Addendum #	2	Date Issued	10-25-2024
Project Name Job #	DSU Woods Hall Improvements - Phase 2		20233600
Bid Date Time	November 20, 2024		2 pm MDT

THIS ADDENDUM AMENDS AND BECOMES PART OF THE CONTRACT DOCUMENTS FOR EAPC PROJECT 20233600 DATED 1-16-2024. EACH BIDDER SHALL ACKNOWLEDGE RECEIPT OF THIS ADDENDUM BY MARKING THE ADDENDUM NUMBER AND DATE ON THE BID FORM.

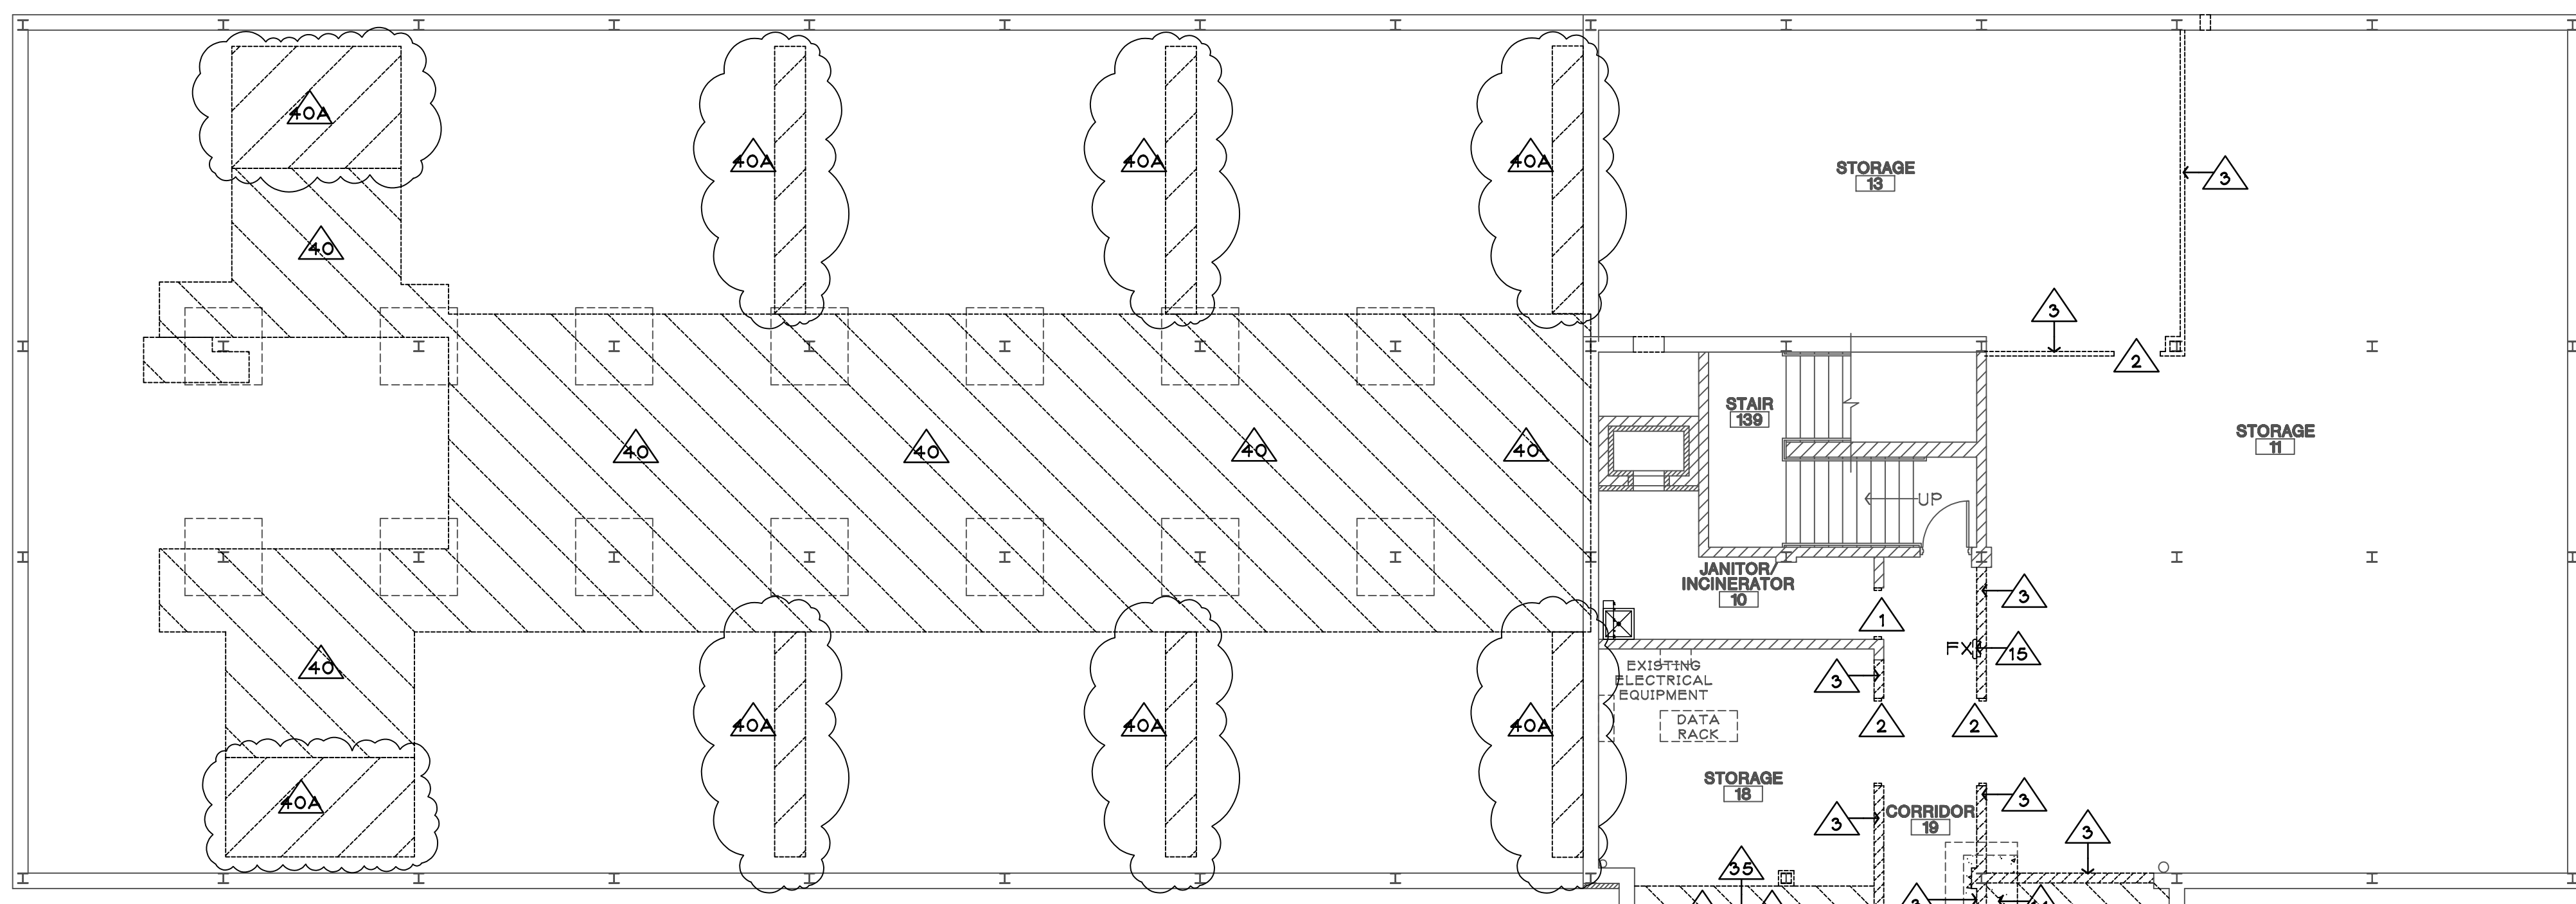
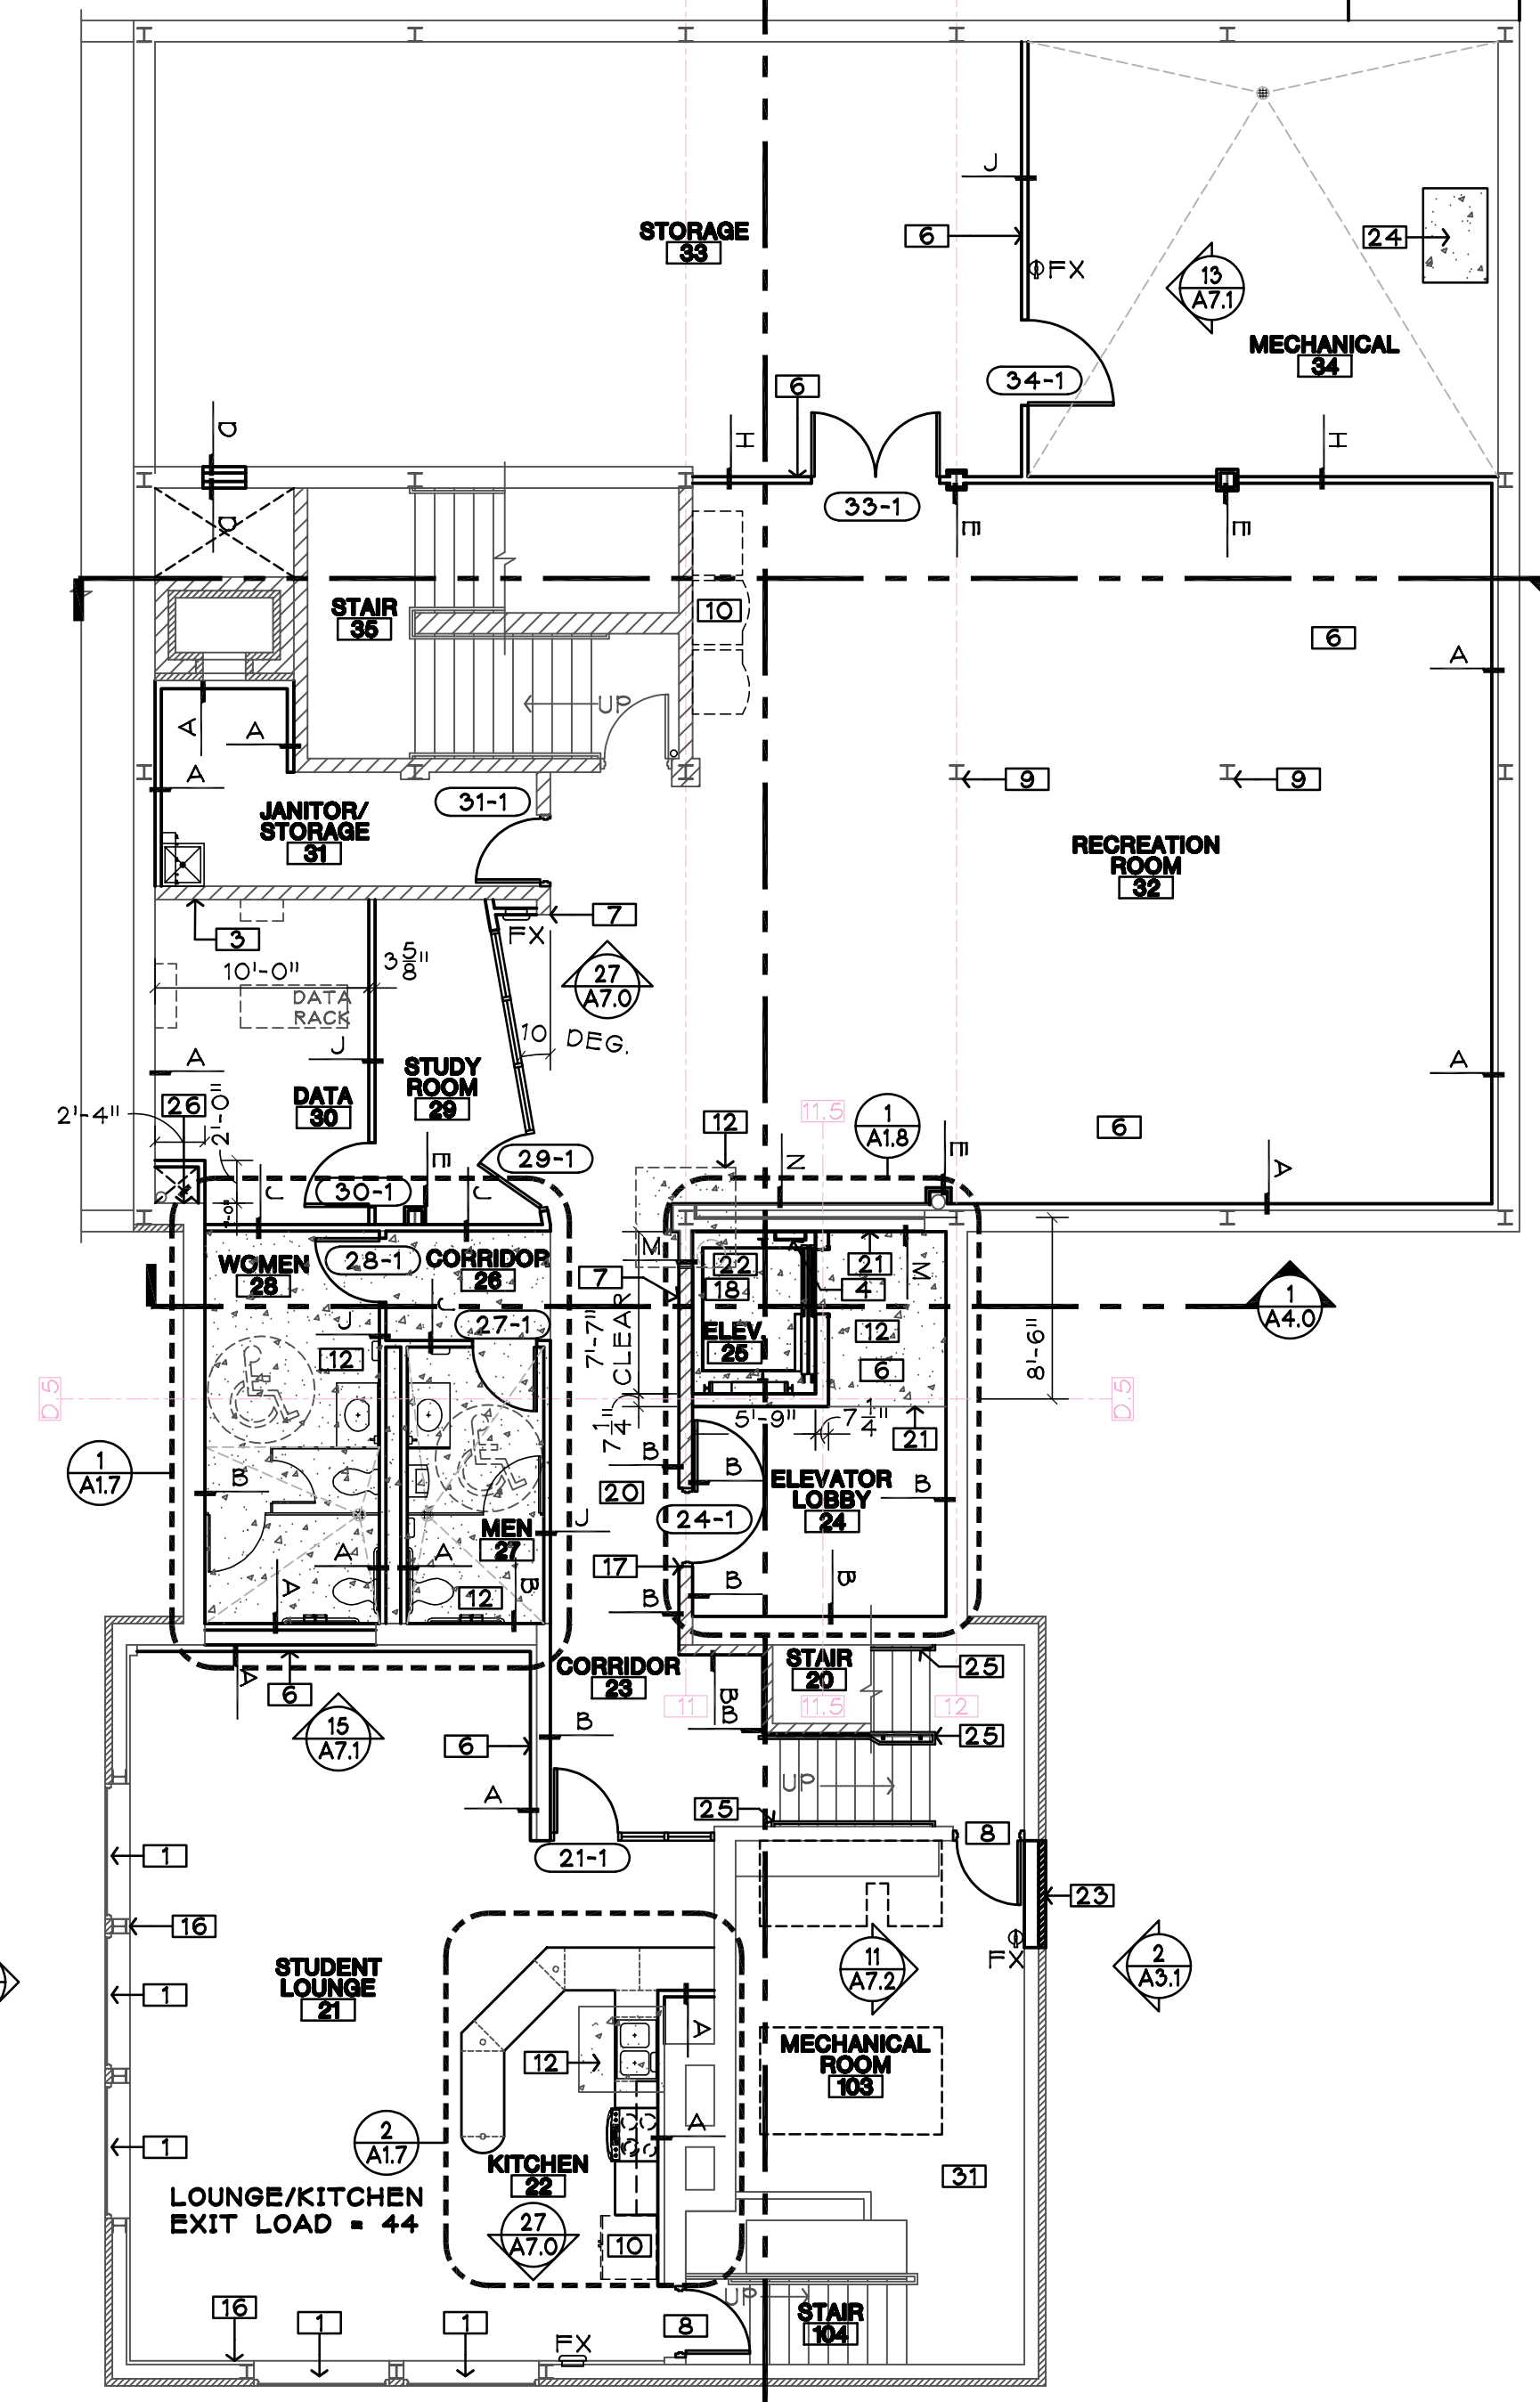
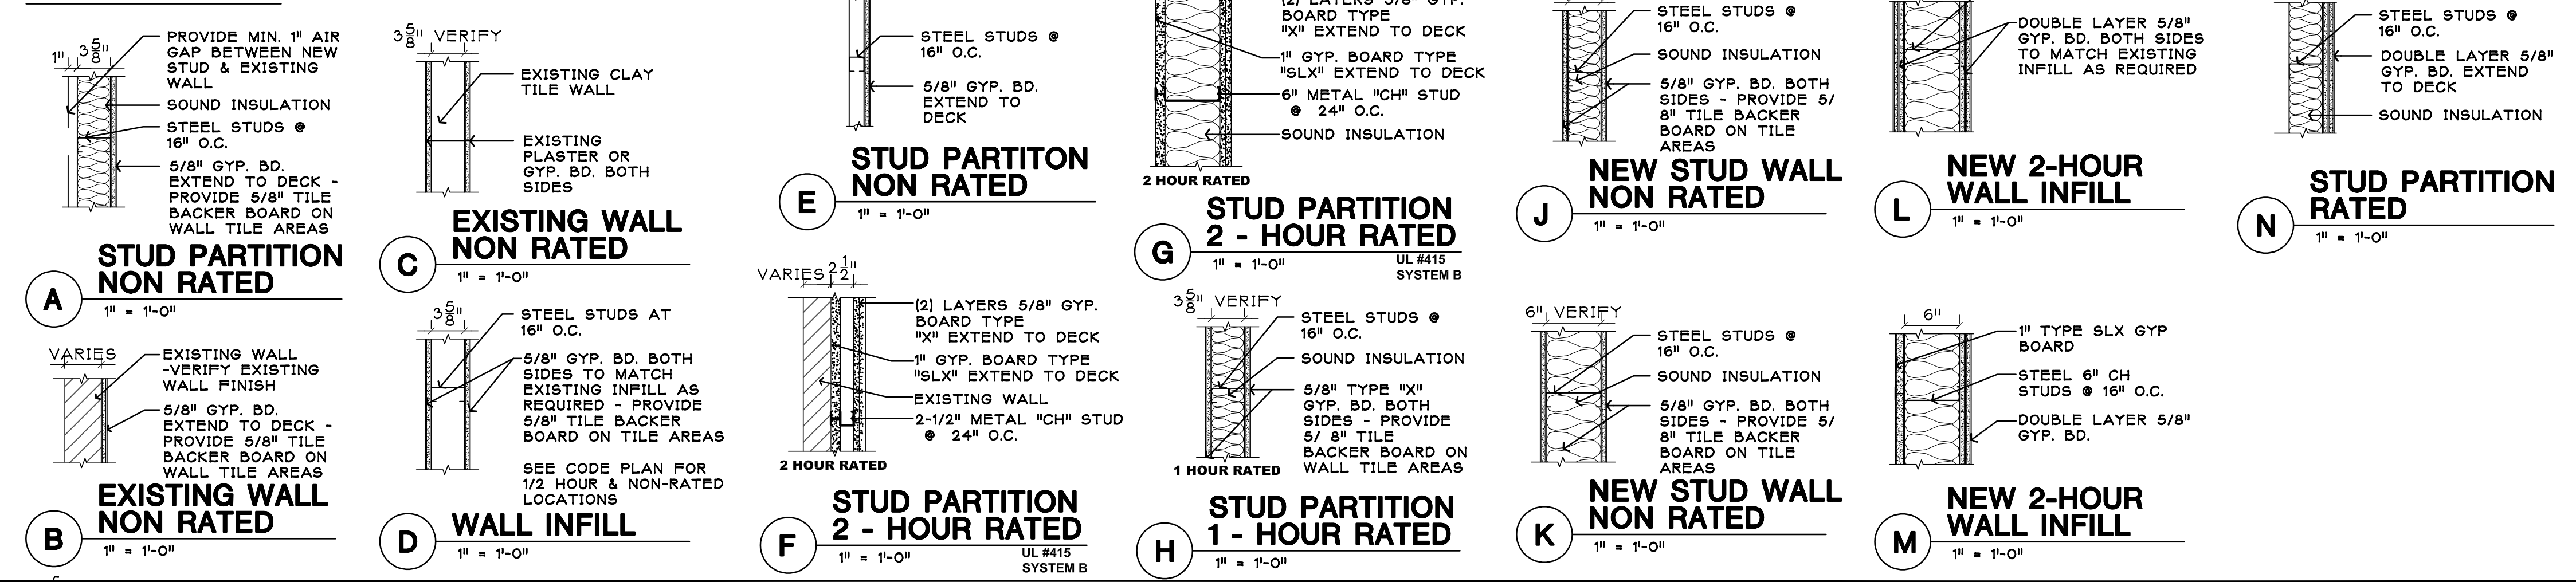
Replace sheet with revised sheet A1.0R, attached. Revision as needed for 3rd floor AC Alternate Bid G-4.

Add Note: Alternate Bid G-4 only: Provide additional existing chase wall repair as needed for installation of 3rd floor AC lines. Coordinate locations with Mechanical and Electrical.

Add Note: Alternate Bid G-4 only: Provide additional existing ceiling repair as needed for installation of 3rd floor AC lines. Coordinate locations with Mechanical and Electrical.
